REVISION TRANSMITTAL

This sheet transmits Revision 2 to SB 34-4171, which:

NAVIGATION - PROLINE FUSION UPGRADE TO PHASE 3 SOFTWARE

Figure 3. Modification of the No. 1 and No. 2 DME System Electrical Wires (Sheet 1)

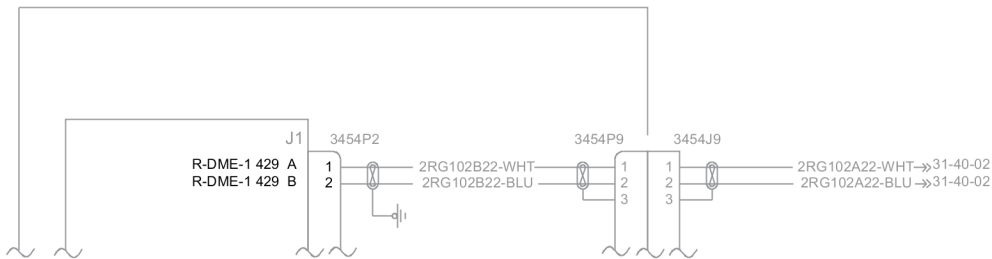
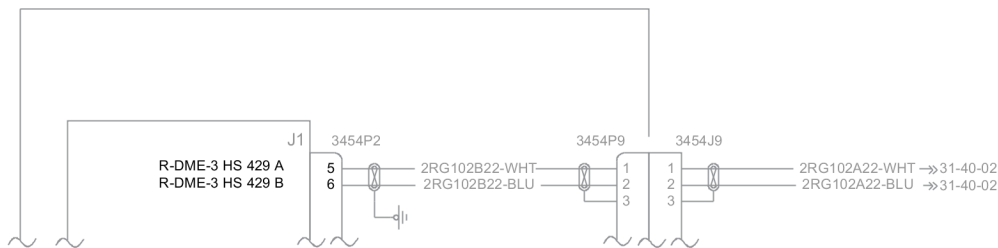
- F. (Refer to Figure 3, Detail A and B.) Do the modification of No. 1 and No. 2 Distance Measuring Equipment (DME) system electrical wires as follows:

- (5) Remove electrical wire 1RG102A22-WHT from electrical connector 3454P1 pin "1" and install at pin "5".
 - (6) Remove electrical wire 1RG102A22-BLU from electrical connector 3454P1 , pin "2" and install at pin "6".

- (7) If installed, remove electrical wire 2RG102B22-WHT from electrical connector 3454P2 pin "1" and install at pin "5".
 - (8) If installed, remove electrical wire 2RG102B22-BLU from electrical connector 3454P2 , pin "2" and install at pin "6"

Figure 4. Modification of the No. 1 and No. 2 VHF Communication System Electrical Wires (Sheet 1)

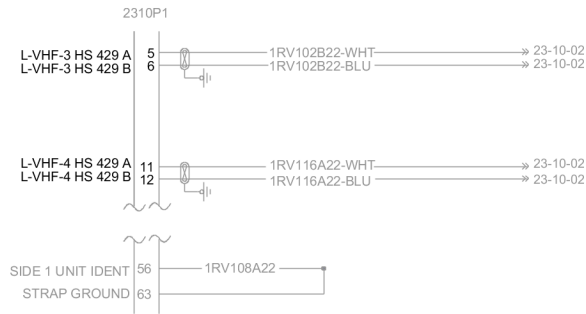
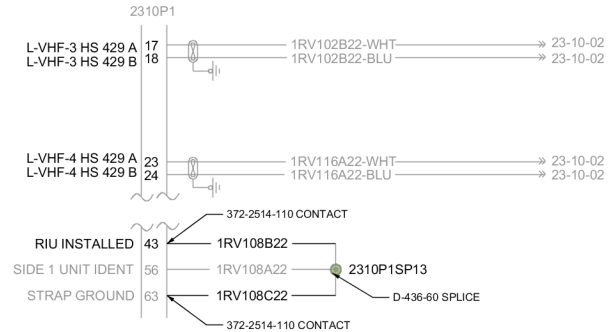
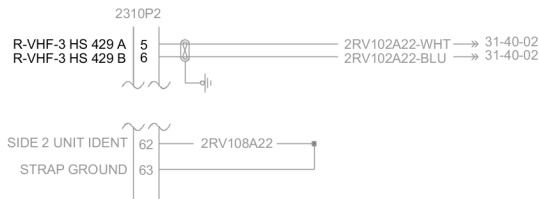
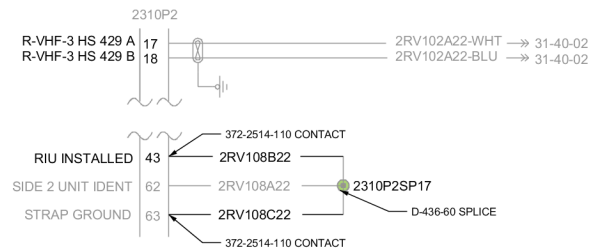
- G. (Refer to Figure 4, Details A and B.) Do the modification of the No. 1 and No. 2 Very High Frequency Communication (VHF) electrical wiring as follows:

- (4) Loosen/remove the No. 2 VHF-4000 transceiver equipment tray and related hardware as necessary to gain access to electrical connector 2310P2
 - (5) Remove electrical wire 1RV102B22-WHT from electrical connector 2310P1 pin "5" and install at pin "17".

- (6) Remove electrical wire 1RV102B22-BLU from electrical connector 2310P1, pin "6" and install at pin "18".
 - (7) Remove electrical wire 1RV116A22-WHT from electrical connector 2310P1 pin "11" and install at pin "23".

- (8) Remove electrical wire 1RV116A22-BLU from electrical connector 2310P1 pin "12" and install at pin "24".
 - (9) Remove electrical wire 1RV108A22 from electrical connector 2310P1 pin "63". Cut the 1RV108A22 electrical wire to remove pin. (Refer to the King Air Chapter 20, Standard Practices - Airframe) .

Figure 6. Removal of the 130-340683-0399 Placard and Installation of the 130-340683-0403 Placard (Sheet 1)

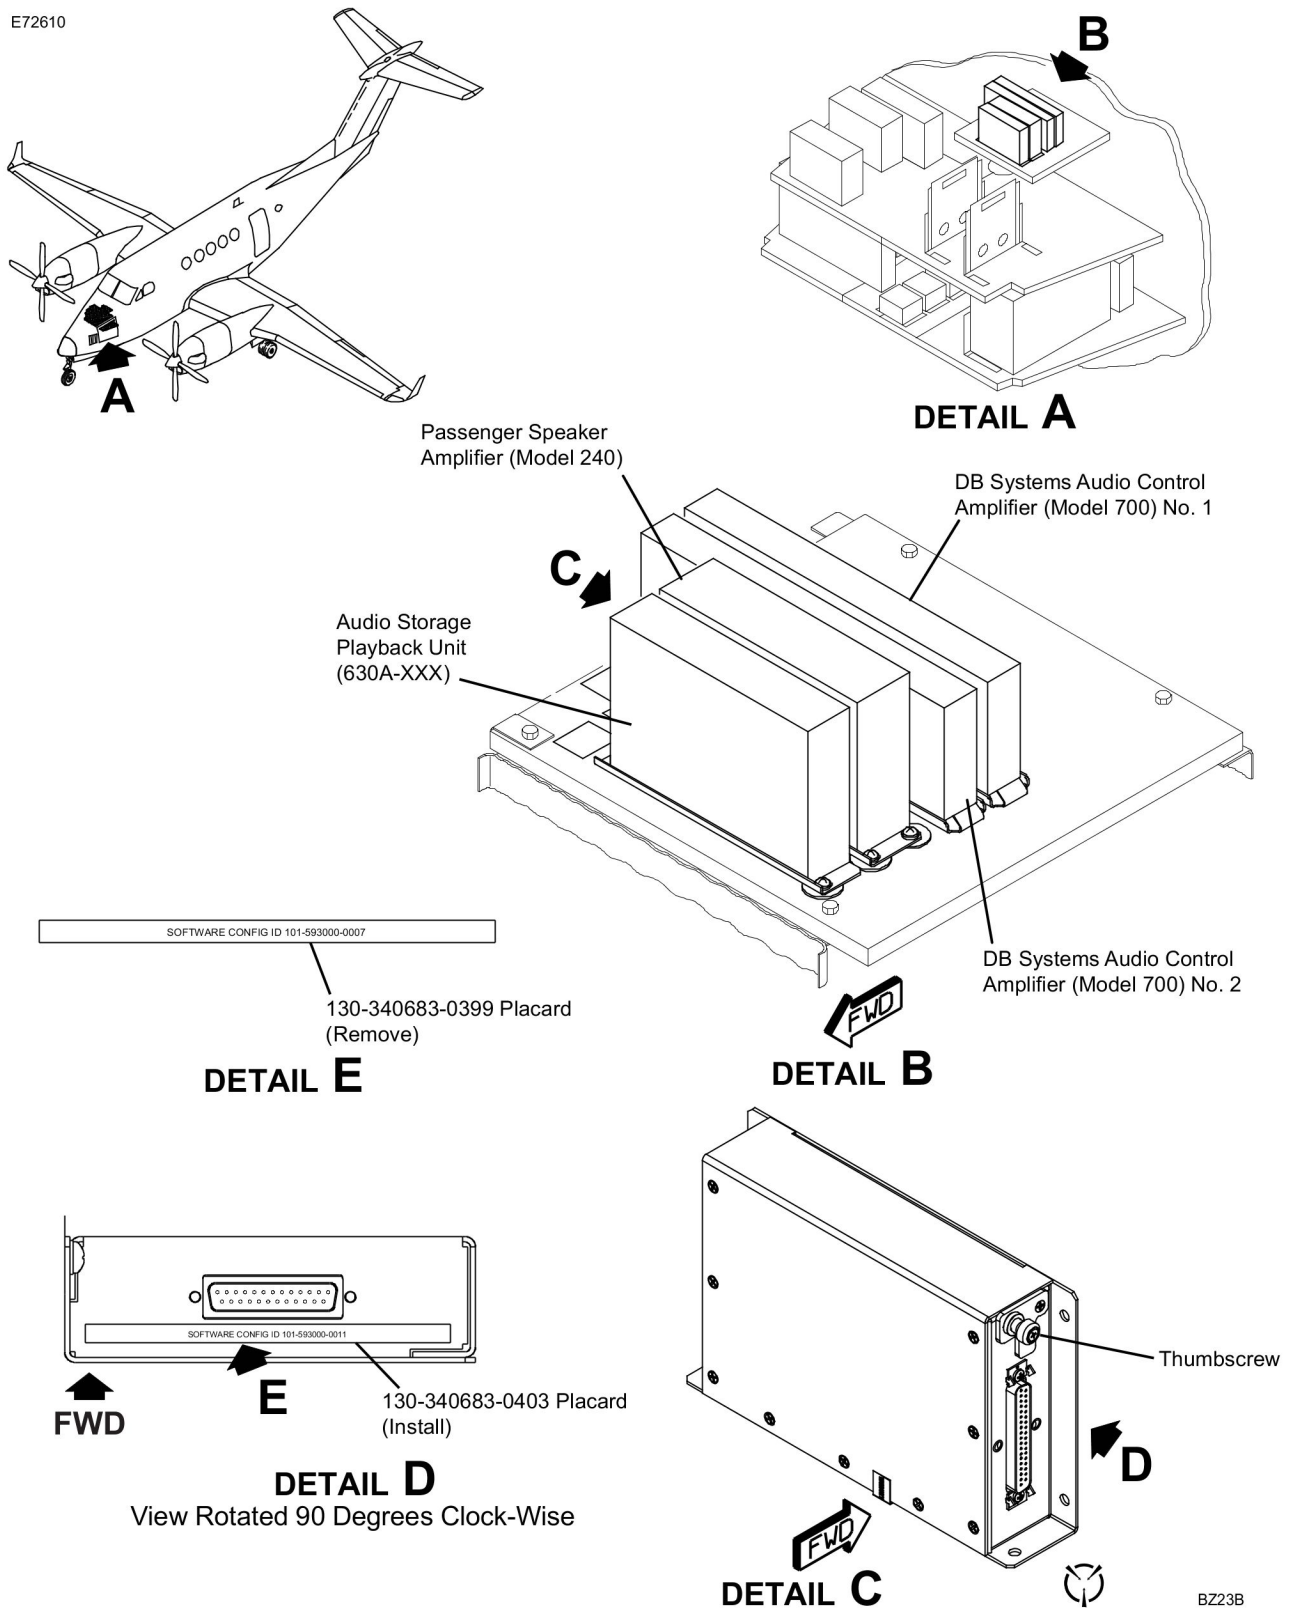
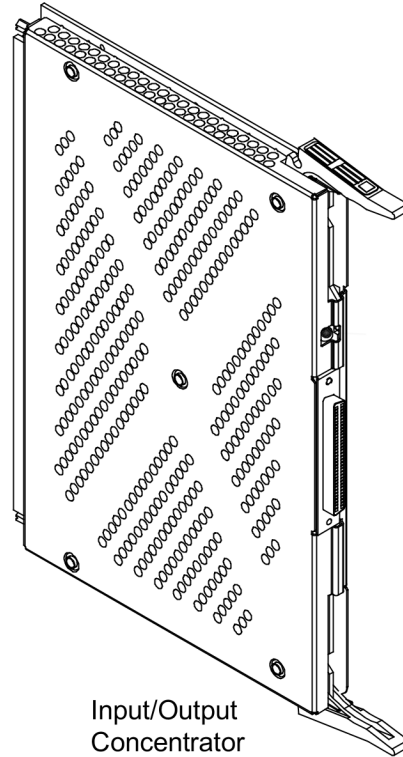
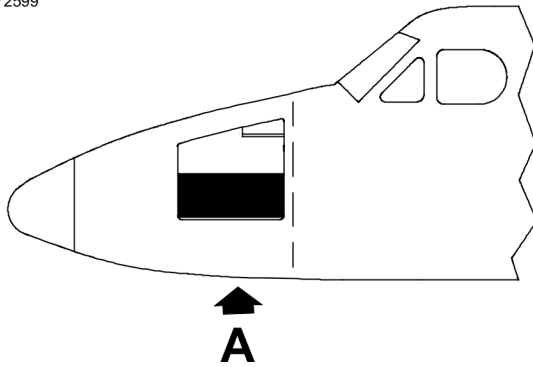
- (6) Install the NGS303-2350P21SP1-22 in electrical connector 2350P21 pin "17".
 - (7) (Refer to Figure 6, Detail D.) Remove the 130-340683-0399 Placard from the audio storage and playback unit (ASPU).

- (8) (Refer to Figure 6, Detail D.) Install the 130-340683-0403 Placard on the back of the audio storage and playback unit (ASPU).
 - (9) Install the audio storage and playback unit (ASPU) (Model 630A-XXX) in the aircraft. (Refer to the Super King Air B200GT/B200CGT Fusion Maintenance Manual, Chapter 23, - Audio Storage and Playback Unit (ASPU) - Removal/Installation.)

Figure 7. Installation of the Pro Line Fusion Phase 3 Input/Output Concentrator (IOC) Card (Sheet 1)

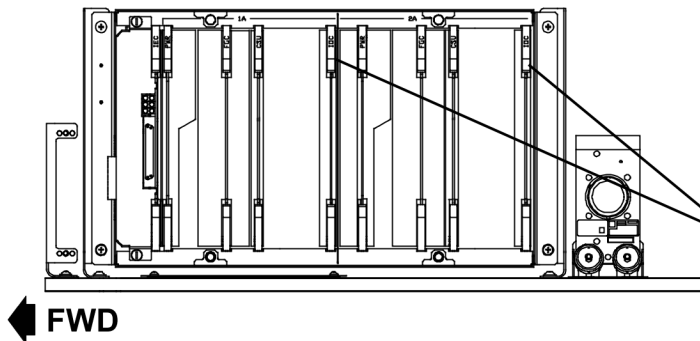
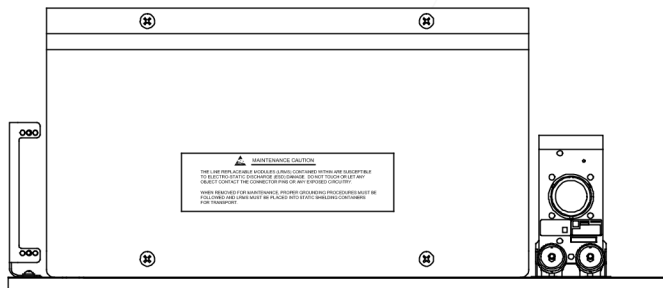
- I. Install new dash number IOC cards as follows:
- (1) (Refer to Figure 7, Detail A.) Remove two 822-1361-620 IOC cards from the aircraft. (Refer to Super King Air B200GT/B200CGT Fusion Maintenance Manual, Chapter 31 - Input/Output Concentrator (IOC) - Removal/Installation.)

- (2) (Refer to Figure 7, Detail A.) Install two 822-1361-622 IOC cards on the aircraft. (Refer to Super King Air B200GT/B200CGT Fusion Maintenance Manual, Chapter 31 - Input/Output Concentrator (IOC) - Removal/Installation.)

Figure 8. B300/B300C Installation of the SMS Inhibit Annunciator Switch (Sheet 1)

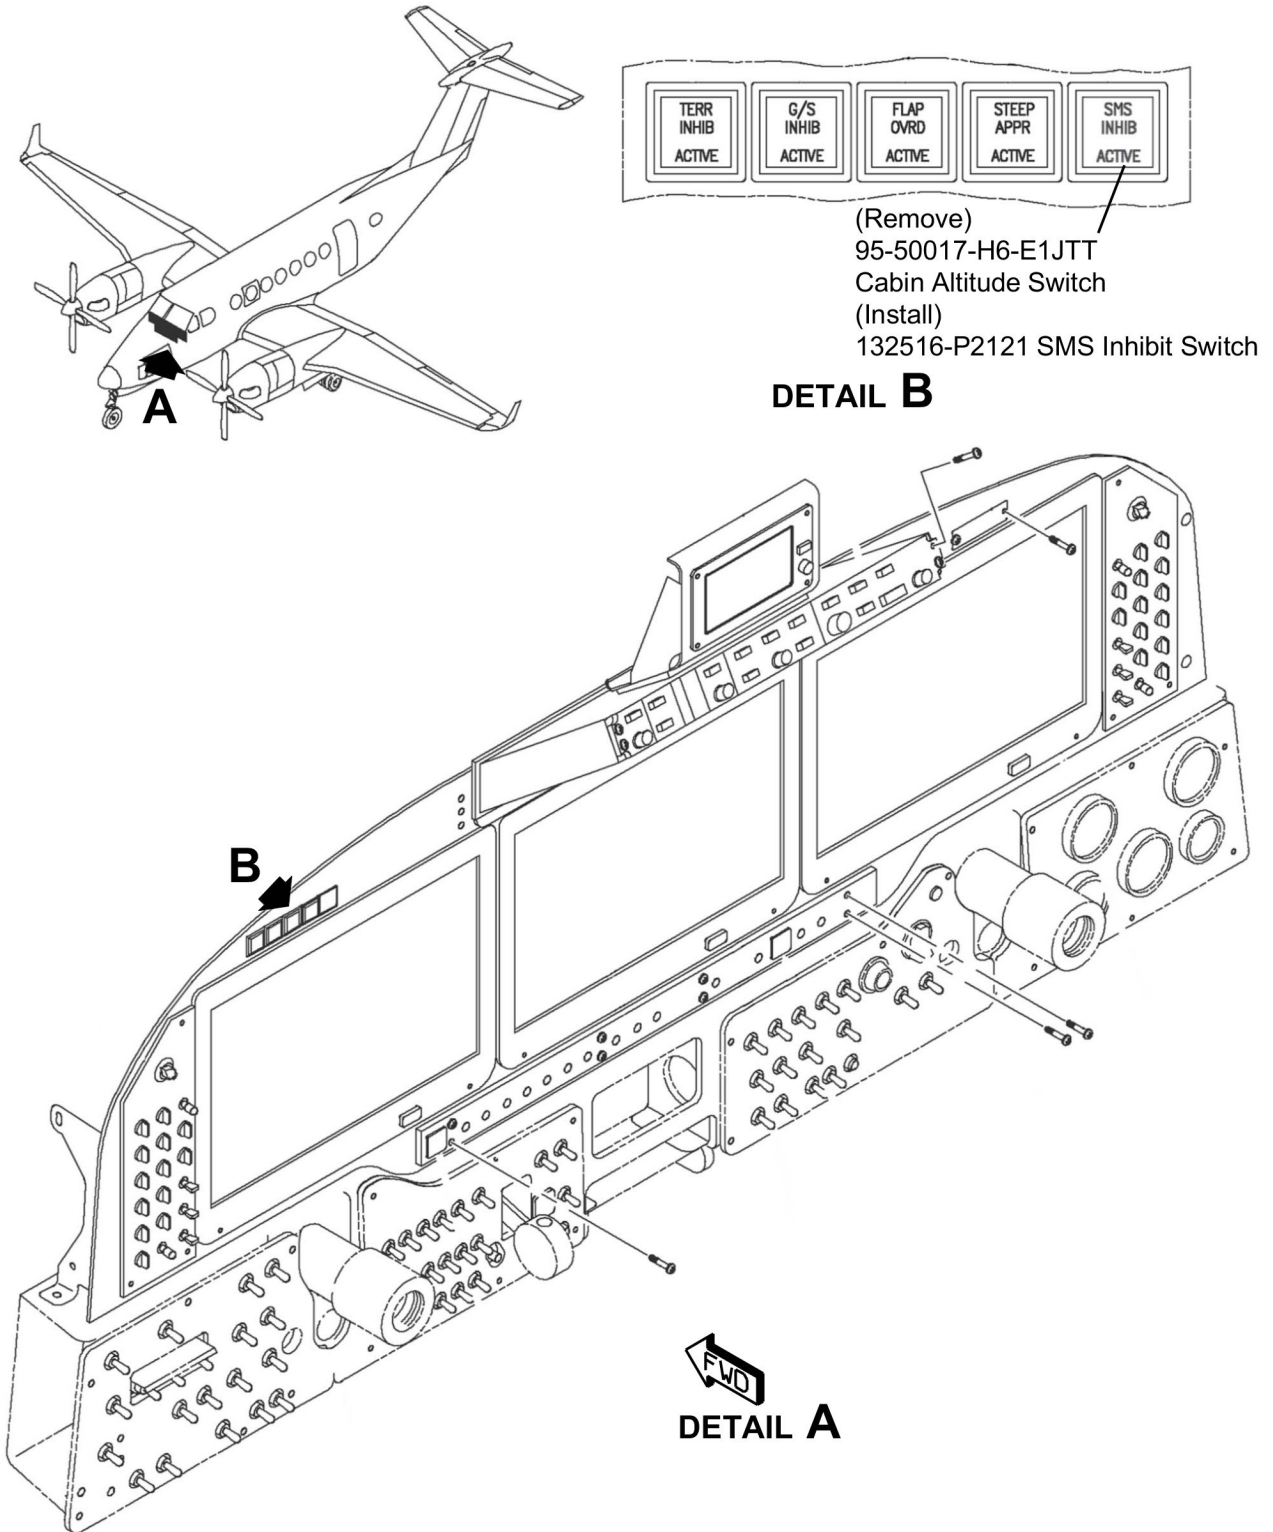
- A. (Refer to Figure 8, Detail B.) Remove the 95-50-17-H6-E1JTT Cabin Altitude Annunciator Switch from the instrument panel.
- B. Disconnect electrical connector 3160DS1 from the cabin altitude annunciator switch.

Figure 9. Modification of the Aircraft Electrical Wires (Sheet 1)

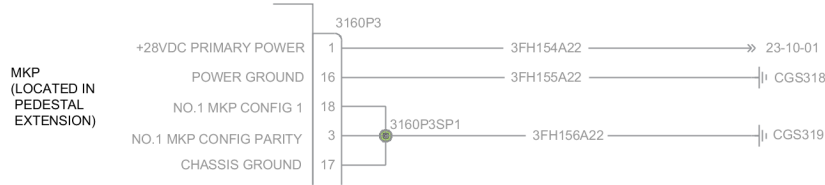
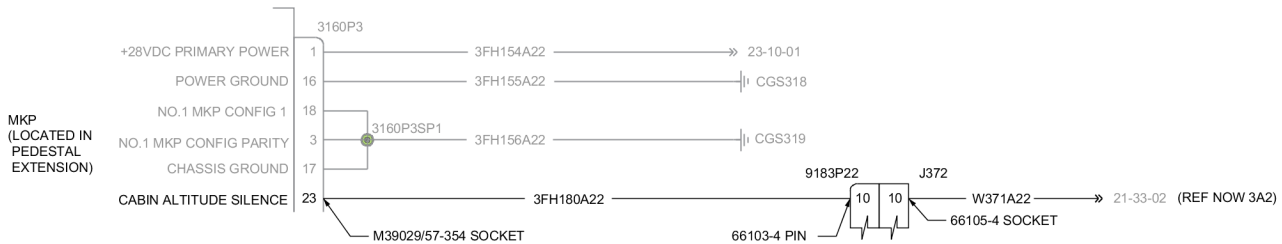
- D. (Refer to Figure 9, Sheet 1.) Do the modification of the aircraft electrical wires as follows:
 - (1) Remove the primary flight display (PFD) from the aircraft. (Refer to the Super King Air B300/B300C Fusion Maintenance Manual, Chapter 31, Adaptive Flight Displays (AFD-3010) or (DCP-3000) - Removal /Installation.)

- (12) Remove electrical wire LH123B22 from electrical connector 9183P22 pin "10".
NOTE: Electrical wire LH123B22 will be permanently removed at Step 10.K(7).

Figure 10. Modification of the Cabin Altitude Electrical Relays and System (Sheet 1)

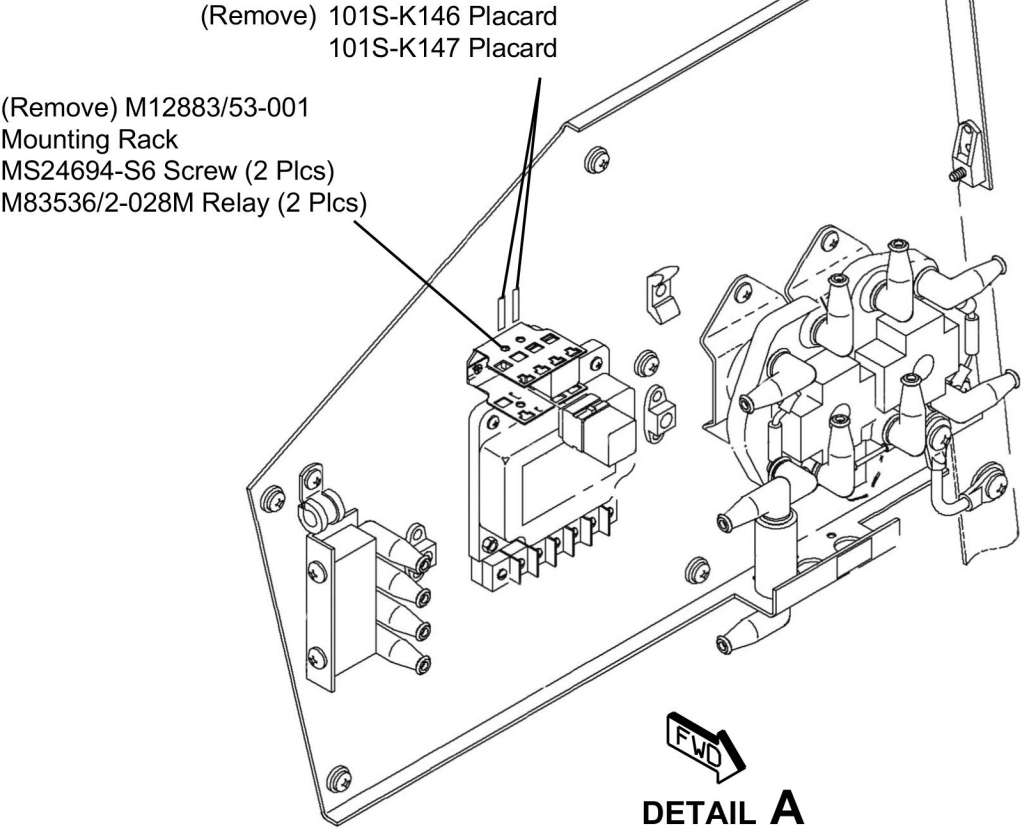
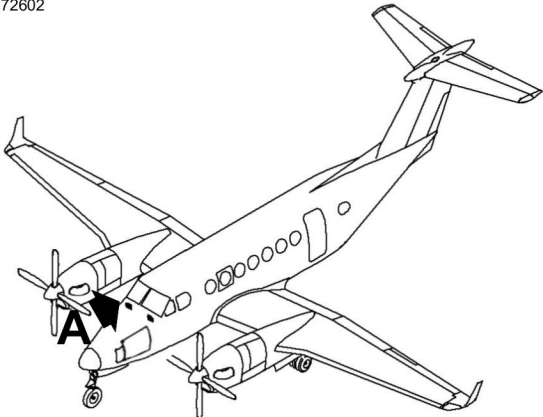
- G. (Refer to Figure 10, Detail A.) Do the modification of the cabin altitude annunciator relays and electrical wiring as follows:
- (1) If necessary, remove the right forward flight compartment equipment panel from the aircraft. (Refer to the Super King Air B300/B300C Fusion Maintenance Manual, Chapter 31, Right Forward Flight Compartment Equipment Panel - Removal/Installation.)

- (2) Remove the cabin altitude annunciator relays (K146; K147) and related hardware from the right forward flight compartment equipment panel.
 - (3) (Refer to Figure 11, Sheet 1.) Cut and remove electrical wire W380A22 from splice J379SP1 of the K146 Relay.
NOTE: Splice J379SP1 and Relay K146 will be permanently removed from the aircraft at Step 10.G(14).

Figure 11. Modification of the Cabin Altitude Electrical Wires (Sheet 1)

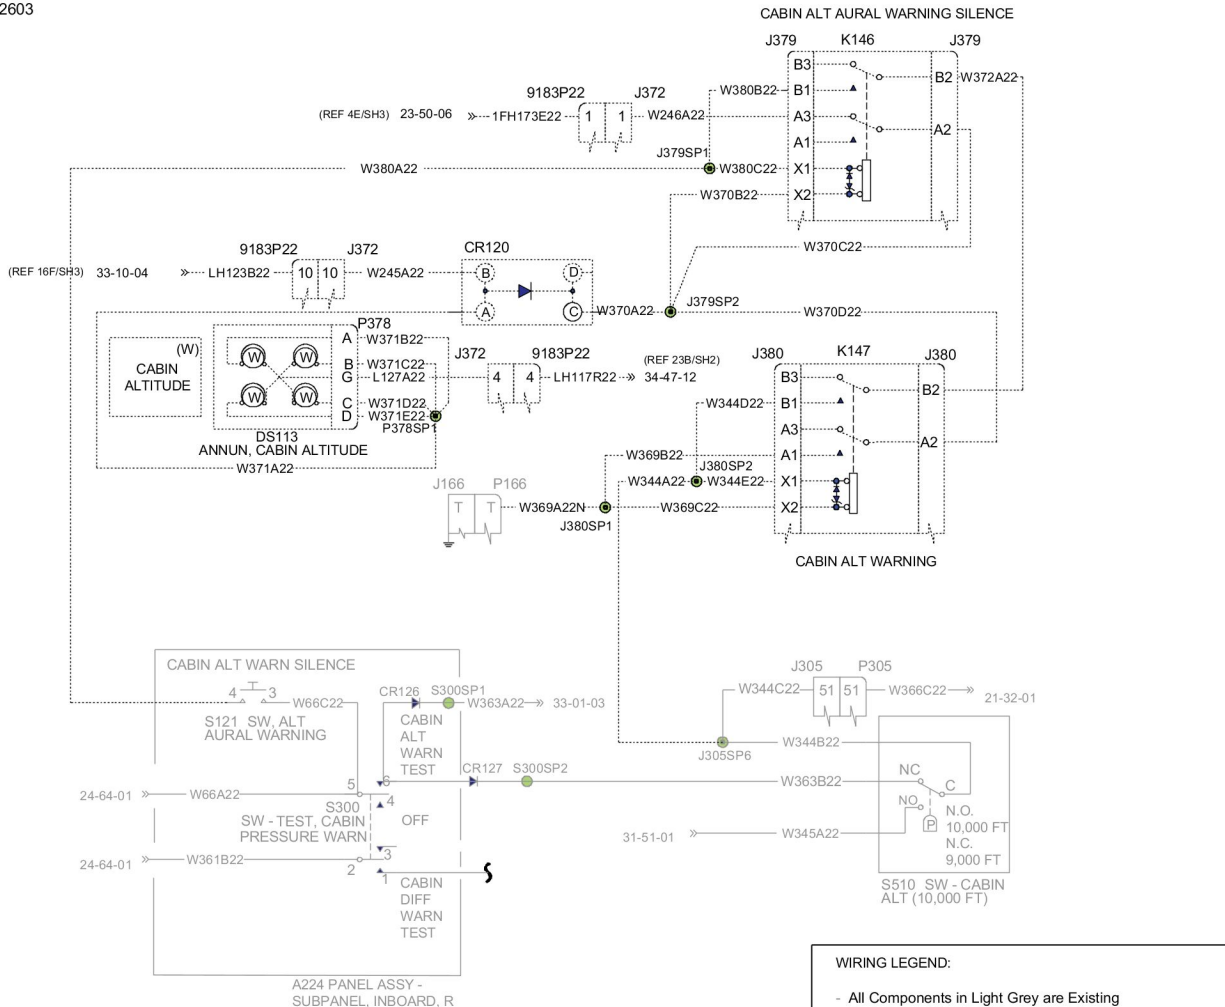
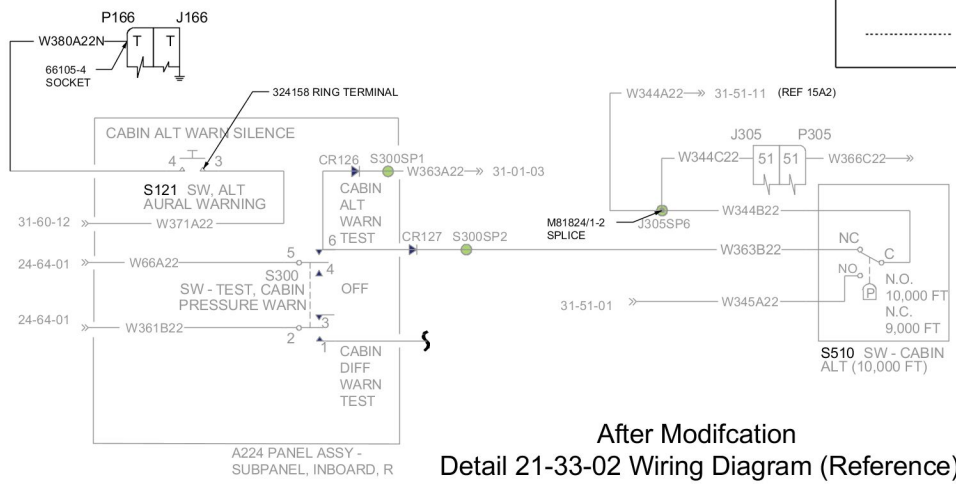
- (14) Permanently remove the following parts, electrical connectors and electrical wires from the aircraft:
 - (a) Remove electrical connectors J379, J380 (K146; K147 Cabin Altitude Annunciator relays) and P378 (DS113 Cabin Altitude Annunciator).

- (b) Remove the CR120 Diode.
 - (c) Remove electrical connectors J379SP1, J379SP2, P378SP1 and J380SP1, and J380SP2 Splices
 - (d) Remove electrical wires W372A22, W380B22, W246A22, 1FH173E22, W380C22, W370B22, W370C22, W370A22, W370D22, W344D22, W344E22, W245A22, W371B22, W371C22, L127A22, W371D22, W371E22, W371A22, W369A22N, W369B22, W369C22, LH117R22 and LH123B22.
NOTE: It is permissible to remove the noted wires entirely from the aircraft, or cut and remove the pins/contacts on the electrical wires at the terminating connector, and to cap and stow each individual electrical wire as necessary.
